STAFF REPORT and DECISION

**Type I Site Plan Review
Fortune Casino Building Expansion
2024-010-SPR**

DATE: 7/3/2024

PROPOSAL: One-story addition and remodel of existing Fortune Casino structure

ST-5

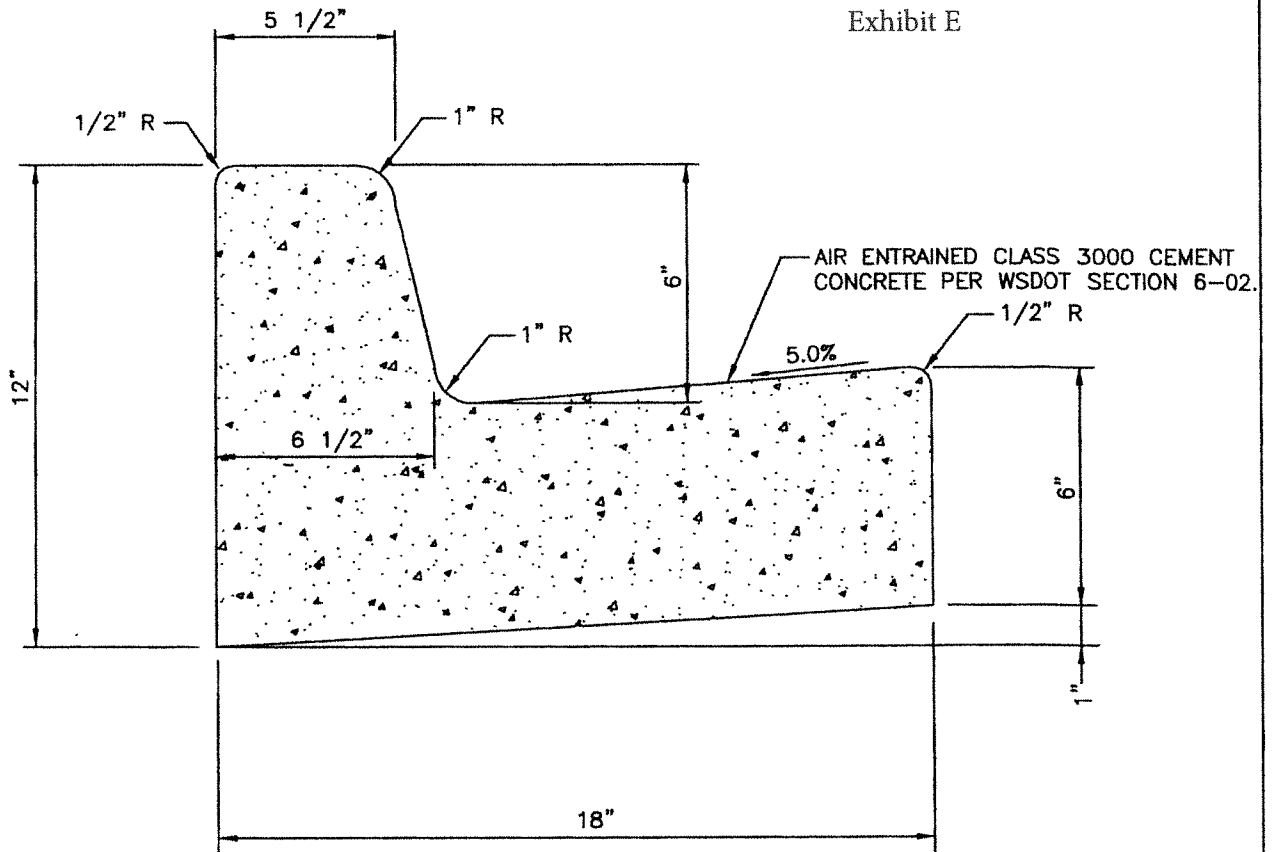
Condition: *Sawcut and remove the existing driveway and place new curb ramp to meet ADA standard, per City of La Center Standard Details and the site plan. Standard Plan ST-8 and ST-7A shall be used to construct the new ramp. Curb and gutter and sidewalk and sidewalk shall be installed to match the new ramp per detail sheets ST-5 (curb and gutter), and sidewalk detail ST-23.*
